TRANS/WP.1/2003/1/Rev.2 18 July 2003

## AMENDMENTS TO AND IMPLEMENTATION OF THE 1968 CONVENTIONS ON ROAD TRAFFIC AND ON ROAD SIGNS AND SIGNALS AND THE 1971 EUROPEAN AGREEMENTS SUPPLEMENTING THEM

## Consolidated proposals for amendments to the Vienna Convention on Road Traffic

Amend model page No. 2 (inside of front cover) as follows:

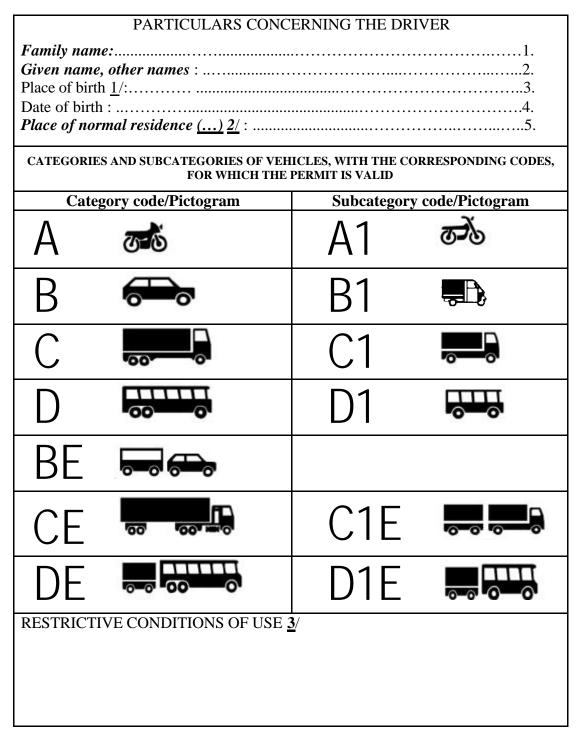
its holder establishes his normal residence there.

- $\underline{1}$  Enter here the name of the Contracting Party in which the holder is normally resident.
- 2/ Space reserved for a list of the States which are Contracting Parties (optional).
